SERVICE BULLETIN No. 158

Electro-Touch[®] Control with Adaptor Harness

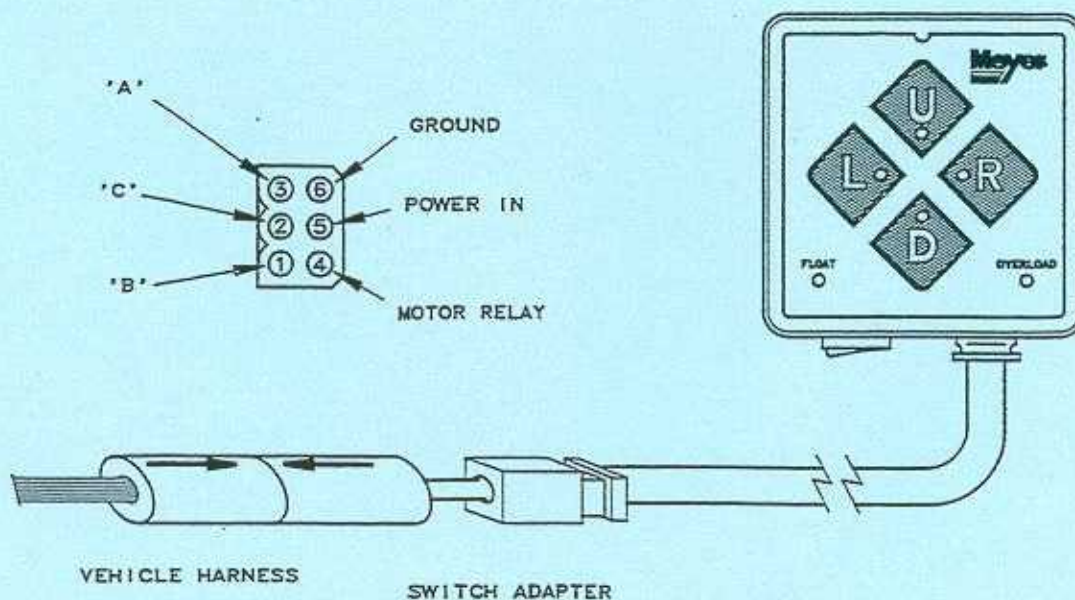
This is a Service replacement Kit for the Electro-Touch[®] Control Part No. 22125.

The new control harness is not compatible with the existing Harness and Fuse Assembly (15725). Therefore an Adaptor Harness (15766) has been provided for quick switch replacement without having to replace the main control harness.

CAUTION should be used when plugging Adaptor Harness (15766) into harness (15725). Both Male and Female ends have alignment tabs and arrows → ← to insure proper installation. Plug the new control (22154) into adaptor harness (15766). Install the two strips of Velcro tape to the mounting bracket. Attach switch control to bracket making sure that control harness is up and out of the way.
